From: Anchondo, Isaac
To: [Collins, Jay](#)
Cc: [Werner, Greg](#); [Proulx, David](#); [Kopriva, Ron](#); [Alley, David](#)
Subject: Leak Location
Date: Thursday, October 13, 2016 1:39:00 PM
Attachments: [leak location.pdf](#)

4. Reason for Request

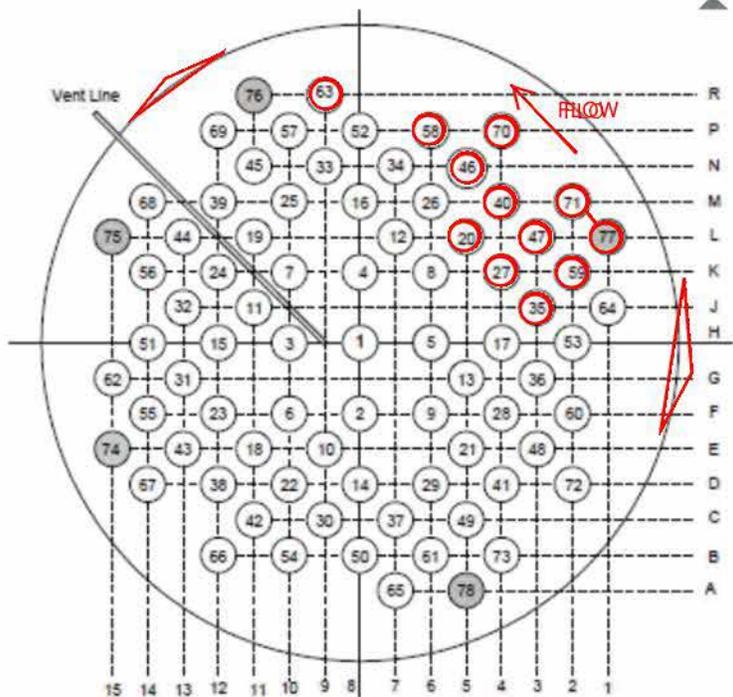
Based on visual examination (VE), deposits resulting from leakage in the canopy seal weld on penetration 77 are on the Reactor Vessel Closure Head. These deposits are dispersed on the reactor head in such a way that it is evident they resulted from the spray pattern, or spray deflection, from the canopy seal weld leak. Other observations noted were: 1) the condition of the head which only had surface rust present rather than wastage; 2) the color and location of these deposits were consistent with spray following the crud burst that was then oxidized by exposure to the atmosphere; 3) there was a layer of white boric acid on top of the deposits in a similar pattern indicating that clean borated water had followed the same path; and 4) no penetrations other than those in the path of the spray/deflection show any abnormal indications.

INSERT FIGURE SHOWING PENETRATION LOCATIONS

With this evidence indicating the condition resulted from the canopy seal weld leak above the head the deposits still obscure the head and prevent the required VE from being performed on the affected penetrations. WCNOG will perform supplemental examinations of the affected penetrations.

Twelve penetrations require supplemental examination in accordance with code requirements. Per paragraph -3200(b) of N-729-1 these supplemental examinations "...shall include volumetric examination of the nozzle tube and surface examination of the partial-penetration weld,...".

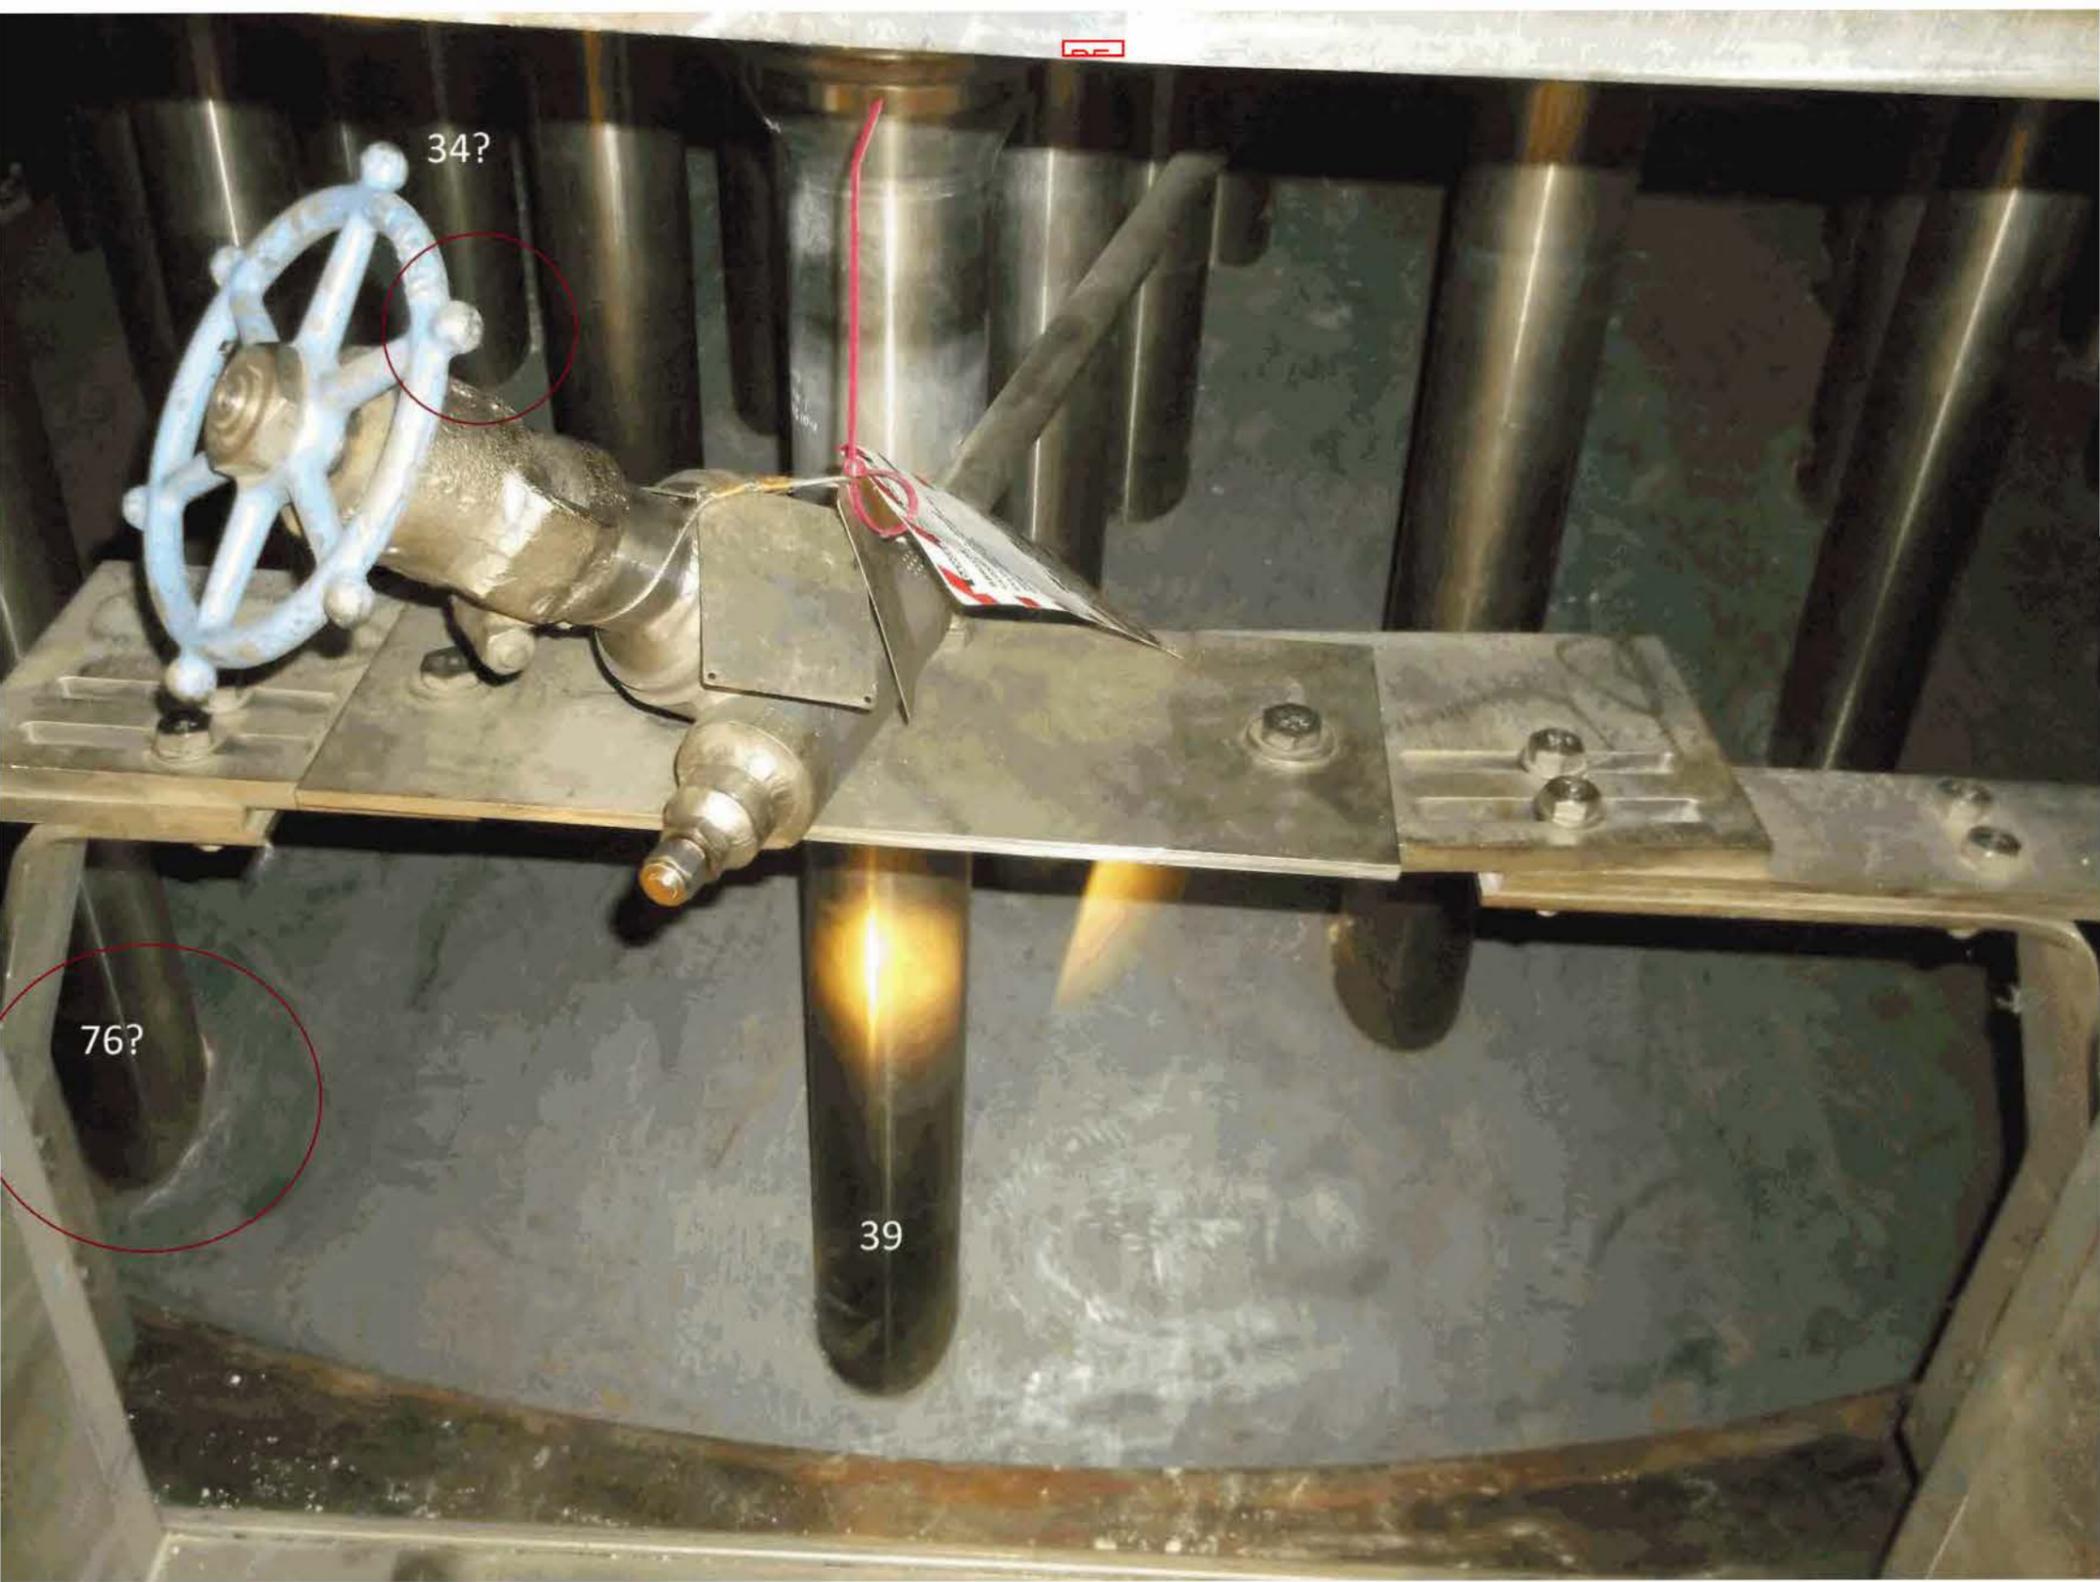
I made an attempt to identify the location of the nozzles to be inspected from some of the pictures that Ron took this past Saturday. Unfortunately, it's hard to see the vicinity of some of the nozzles that you question during the call (i.e., 52, 34, 26).

One item of note, the view next to the vent line is a bit confusing where it's hard to figure out which side you are looking at in relation to the drawing provided.
